Comments: Application G-19496 requests a total of 3.77 cfs (1,692gpm) from up to 2 wells, requiring each well to produce a minimum of 846 gpm. In the well log database, only 1 well log (BAKE 52604) was found in T8S/R43E Sections 30, with a reported well yield of 10 gpm from granite. This may be biased low due to the fact that the well is for domestic use, however it is still an order of magnitude lower than the approximately 846 gpm per well that the application seeks.

ATTACHMENTS:**Well Location Map**G-19496 Stowell
T8S/R43E-Section 30

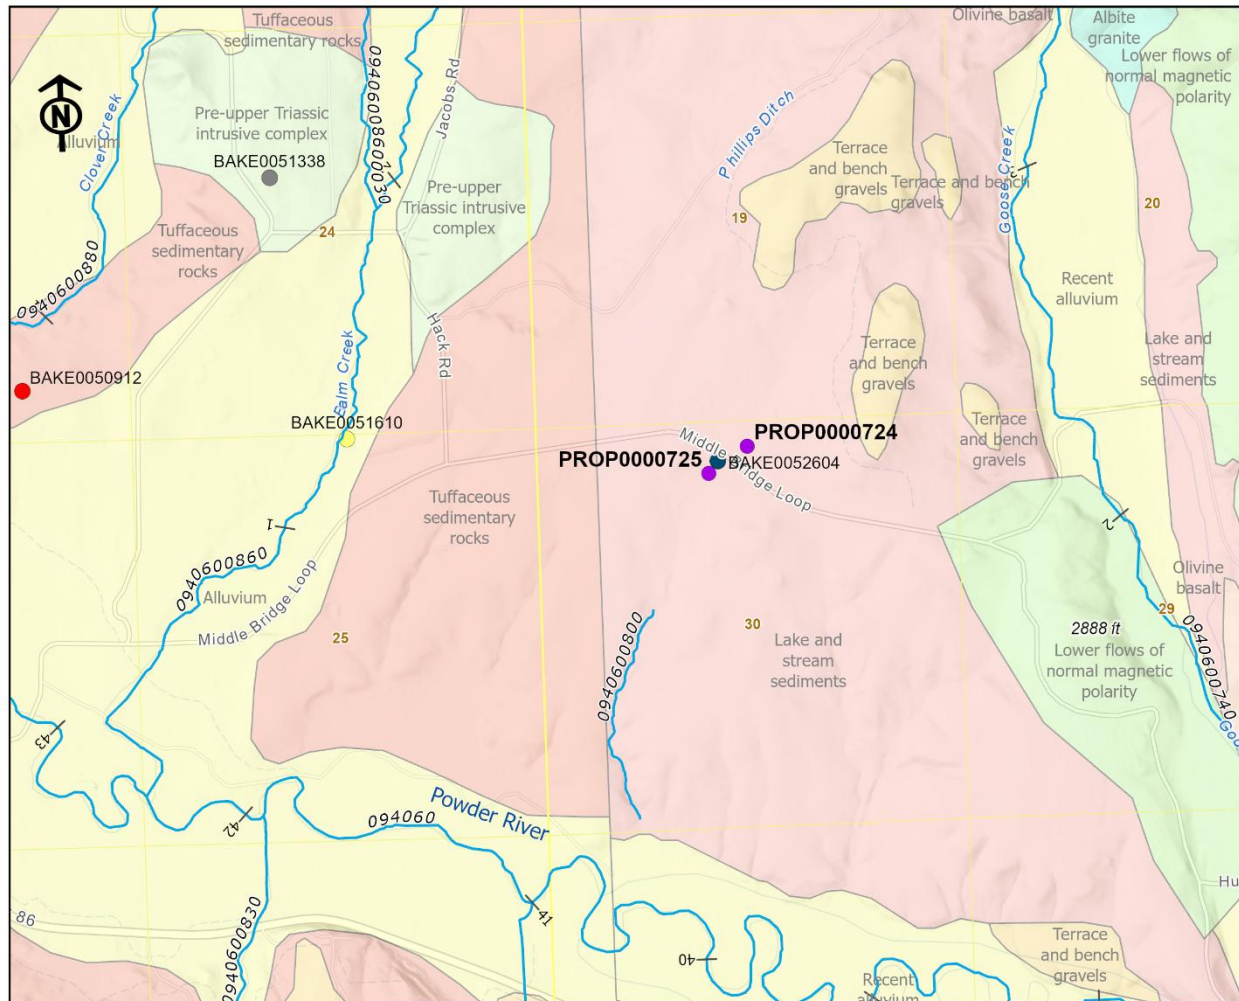
Comments: BAKE 52604 is the only well in the section, however, it is 500 feet shallower than the proposed POAs. It is unknown if water levels will be representative of conditions found at the proposed POAs.
